GEMINI PROJECT

EA Application: Response to Secondary Information Request

MAGNETIC SOUTH

AUGUST 2021

Figure 7: Regulated Vegetation (Of Concern Regional Ecosystem (RE))

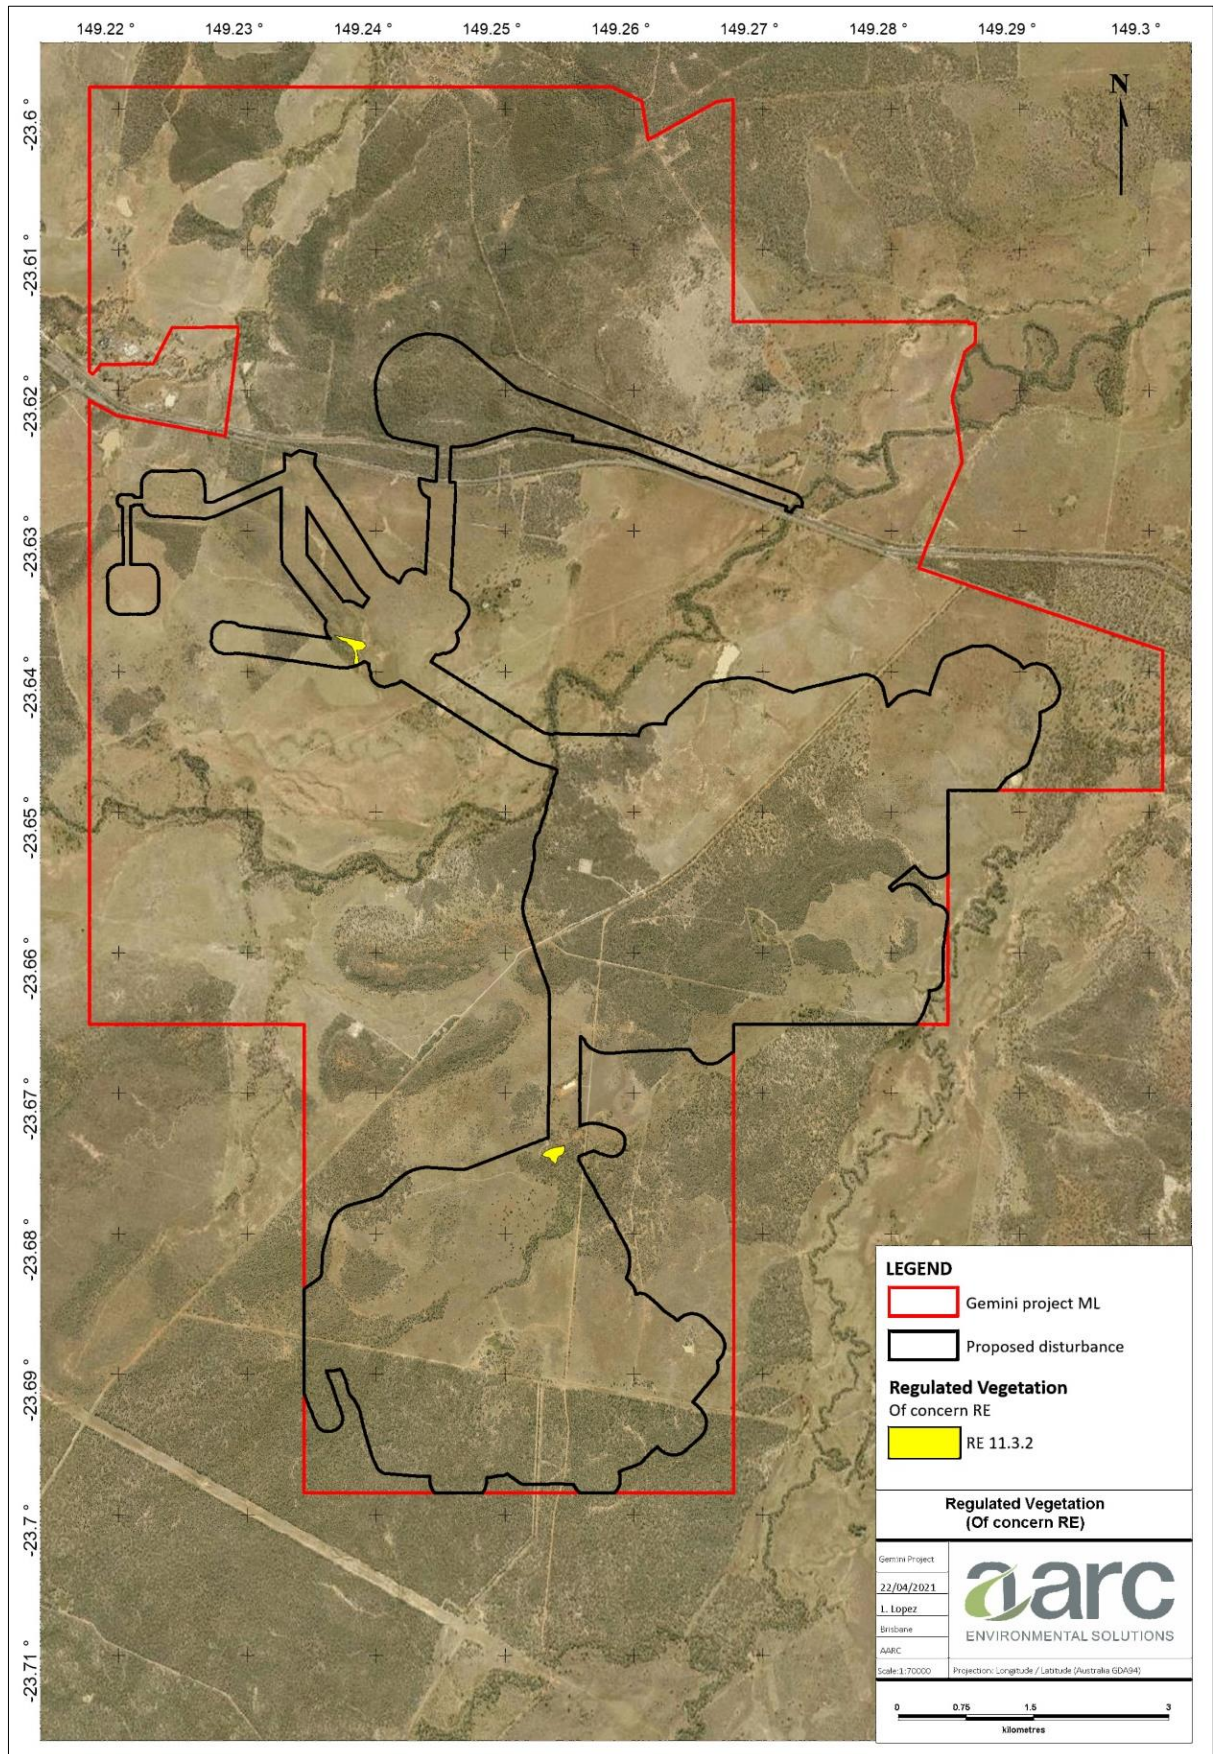
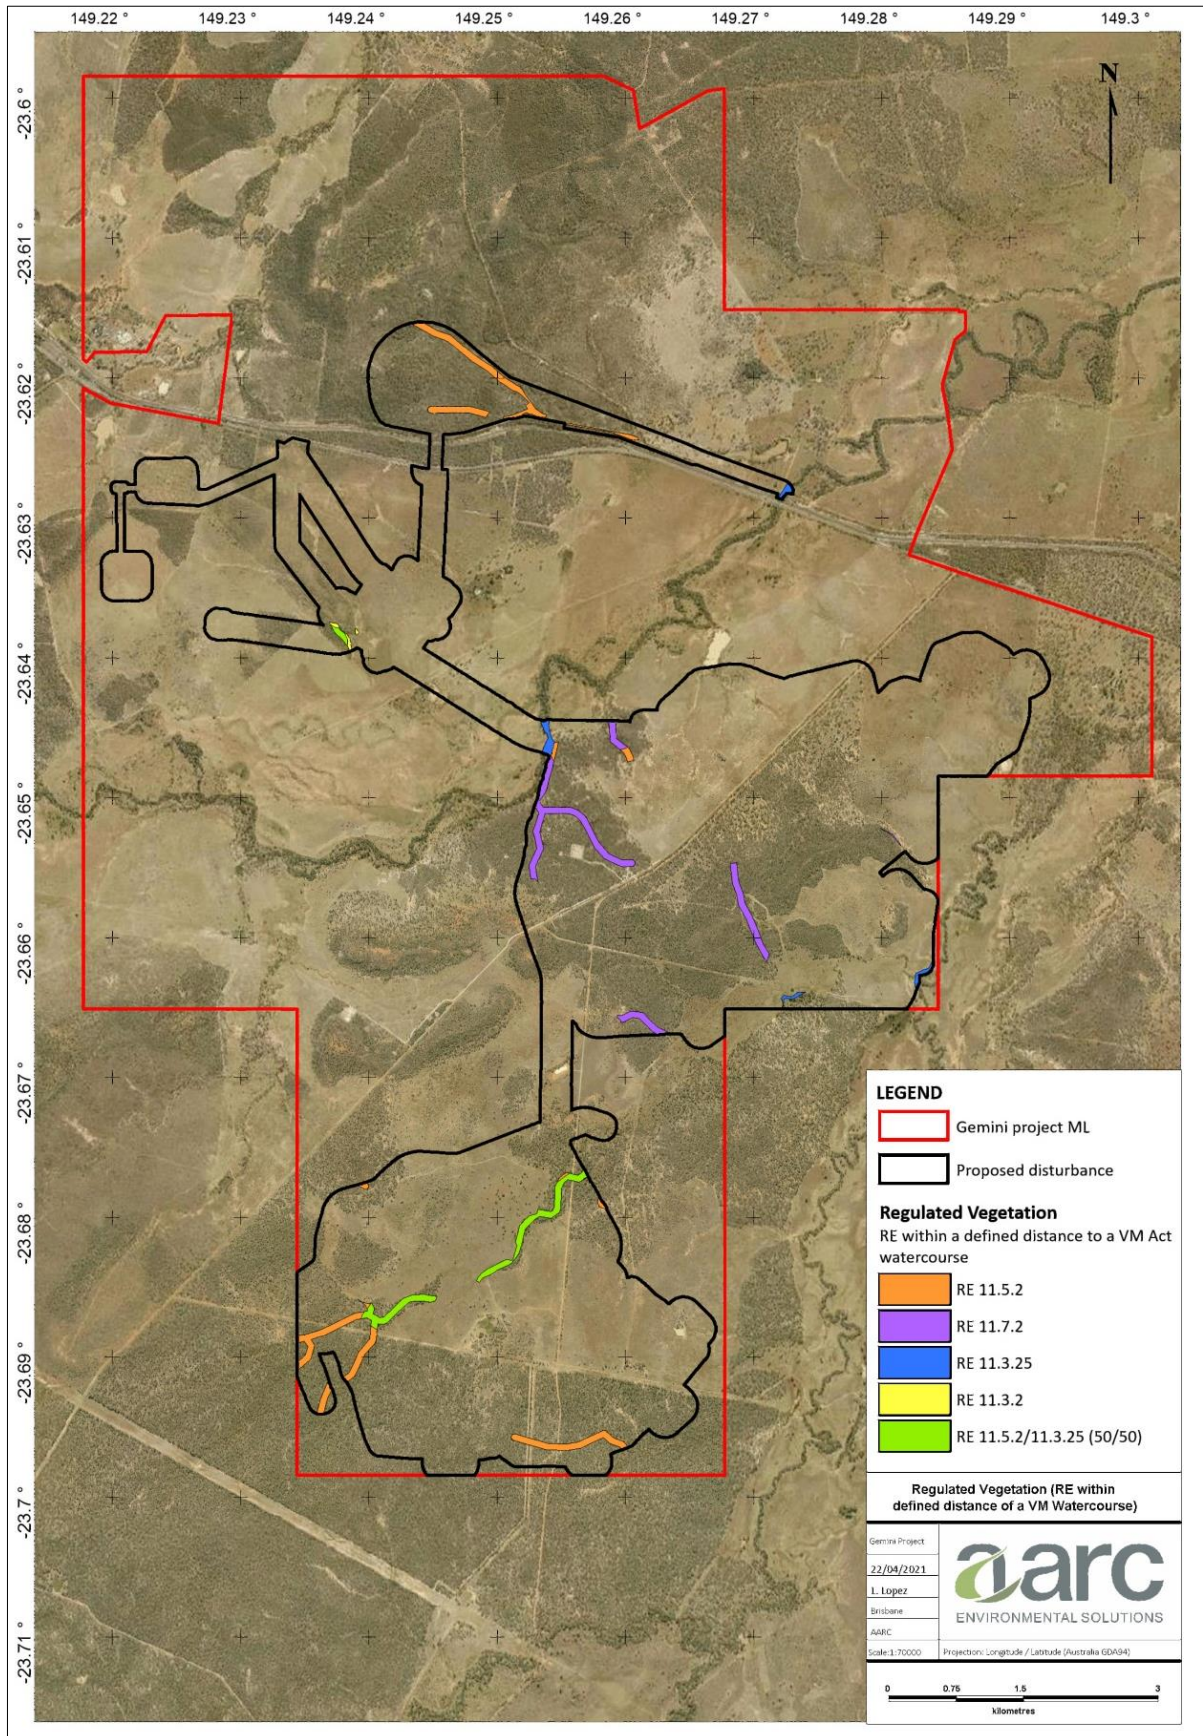
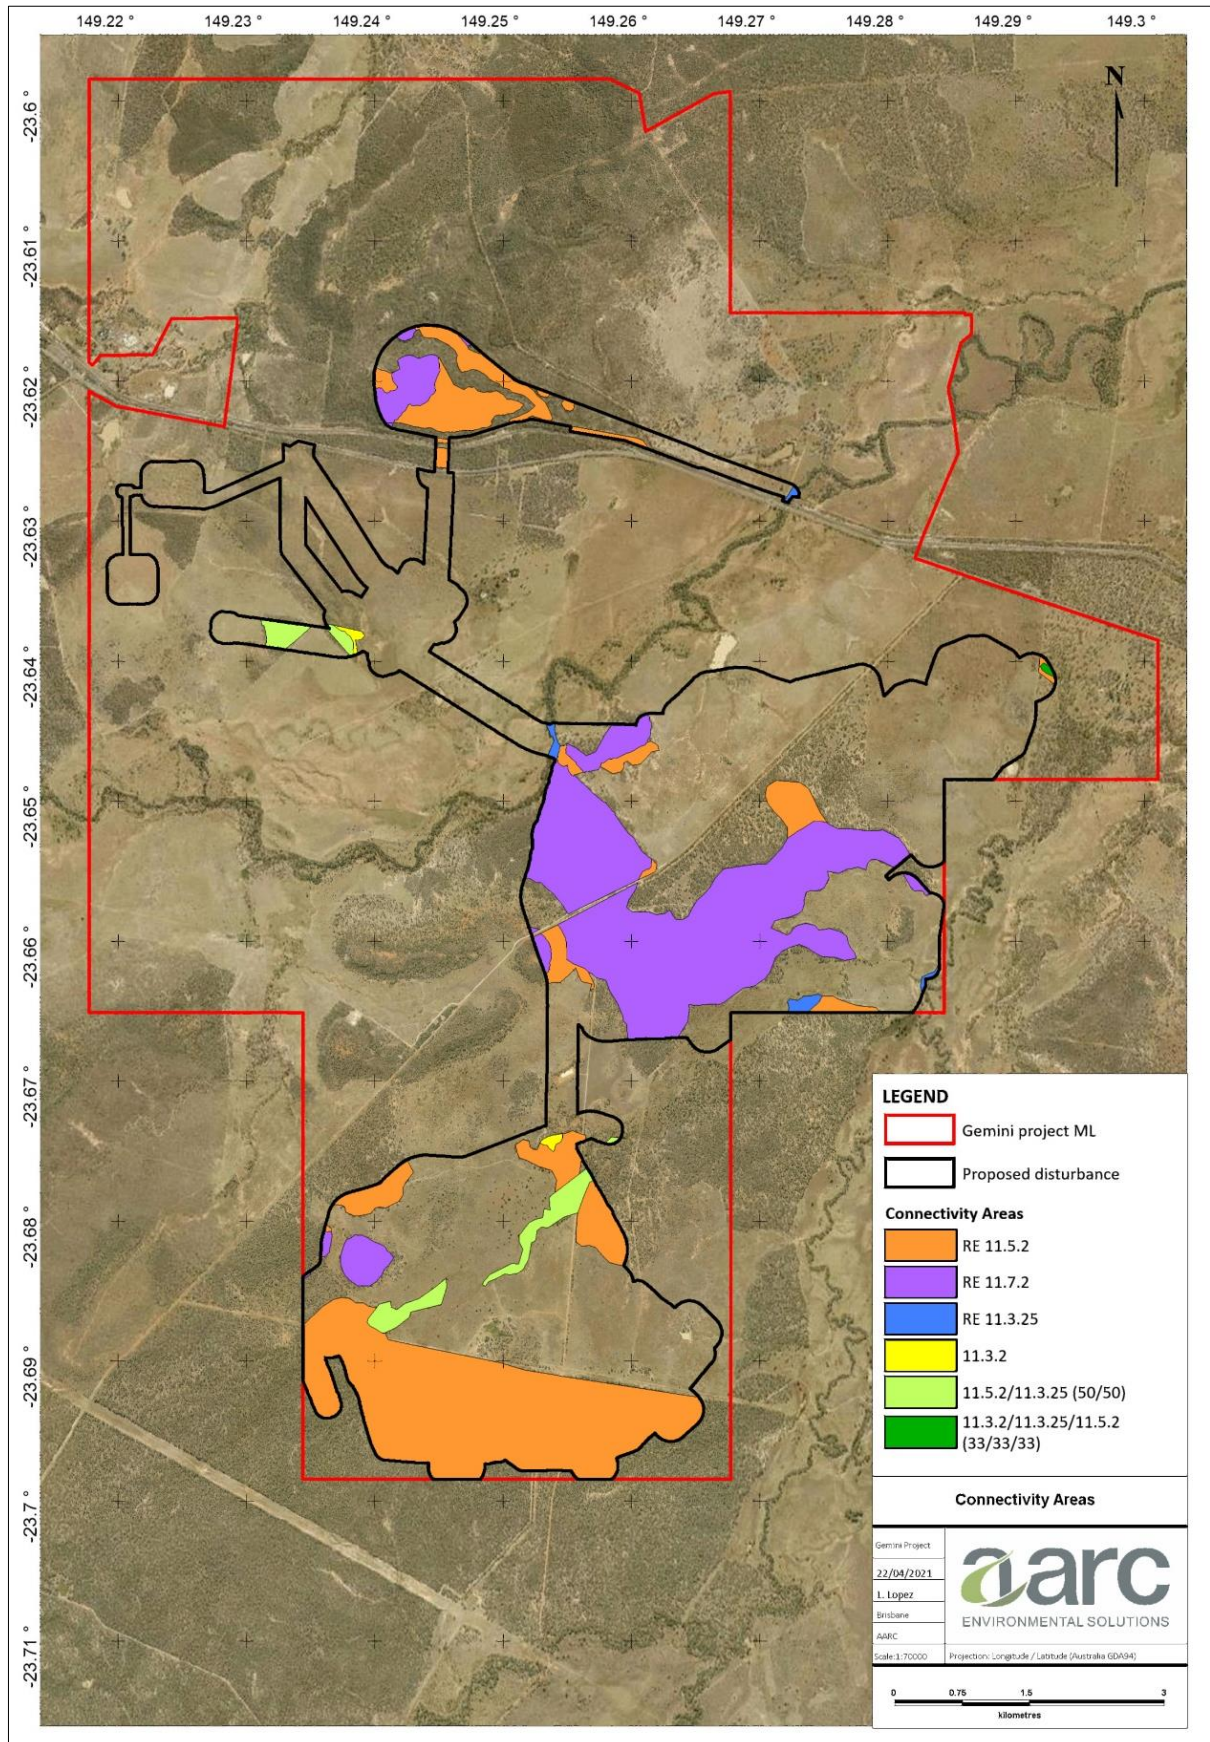
The maximum extent of impact (ha) has been provided as a total area for all regulated vegetation that are regional ecosystems within a defined distance of a vegetation management watercourse and for connectivity areas that are regional ecosystems. It is unclear the maximum extent of impact (ha) to each regional ecosystem identification for both these prescribed matters. The draft EA conditions for impacts to prescribed environmental matters does not include reference figures associated with Table H2 to provide context about the locations of prescribed environmental matters being offset and therefore, it is unclear the locations within the project area they are located.

As per the mining guideline for Model Mining Conditions (ESR/2016/1936, Version 6.02, Effective 07 Mar 17) for Impacts to Prescribed Environmental Matters, provide the location of impact and area (ha) of maximum extent of impact for each regional ecosystem (RE) within the prescribed environmental matters for regulated vegetation and connectivity areas. For the location of impact, multiple figures that reference only the areas of the prescribed environmental matters that are being impacted by the resource activity, is preferable.

A revised Table H2 has been prepared providing a breakdown of the area of each regional ecosystem (RE) for each of the Prescribed Environmental Matters (Table 5).

Figure 10: Annual distribution of winds at the Project site predicted by TAPM/CALMET

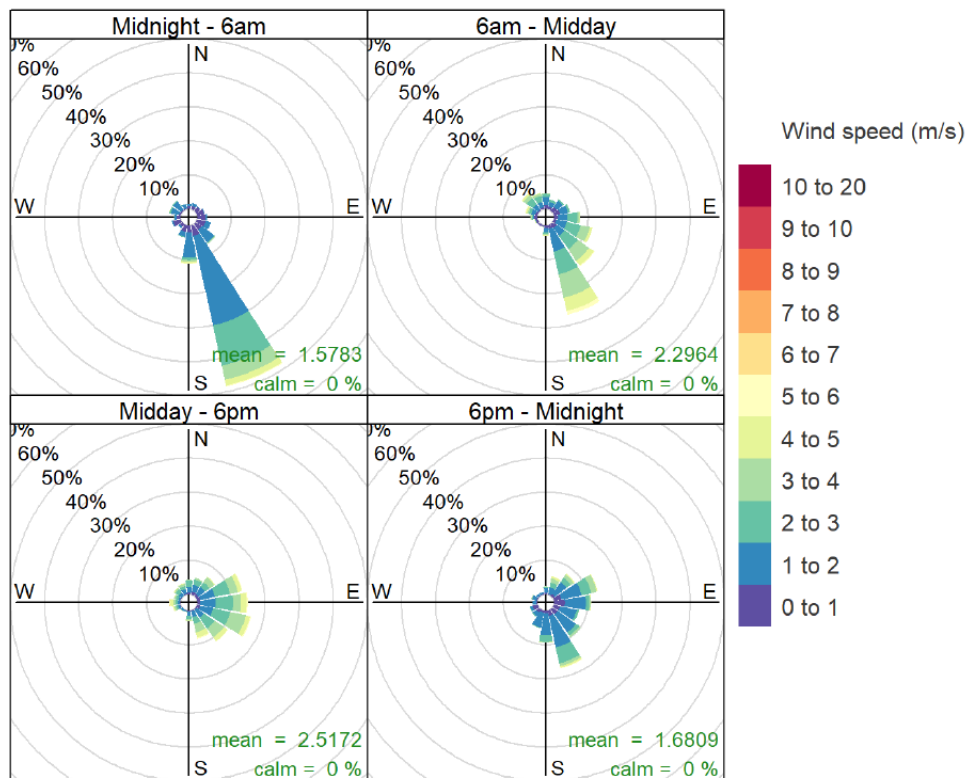
It is noted from Section 3.3.3.2.1 of Appendix L that air quality data from Department of Environment and Science (the department) monitoring station in Blackwater has been used to provide ambient background concentrations. Section 9.2.3.1 of Revised Supporting Information states that data from the department's monitoring station in Blackwater adequately accounts for potential cumulative contributions from surrounding industry, including Bluff Coal Mine. Bluff Coal Mine is 12 kilometres (km) from Gemini Project. Blackwater is located a further 23km west of Bluff Coal Mine, i.e., a total of 35 km from Gemini Project. Ambient background concentrations measured at Blackwater would, therefore, not be representative of the ambient air quality at Gemini, which is a lot closer to Bluff, for example, than Bluff is to Blackwater. Gemini Project is also located in a different direction from Bluff than Blackwater, and therefore, ambient air quality as influenced by prevailing winds, for example, would be quite different.

The Bluff Coal Mine is located approximately 11km to the west of the Project site. As detailed in Appendix A of the AQGGA and shown in Figure 10 and Figure 11 of this report, the meteorological data for the Gemini Project illustrates that winds occur infrequently from the west (less than 8% of the time).
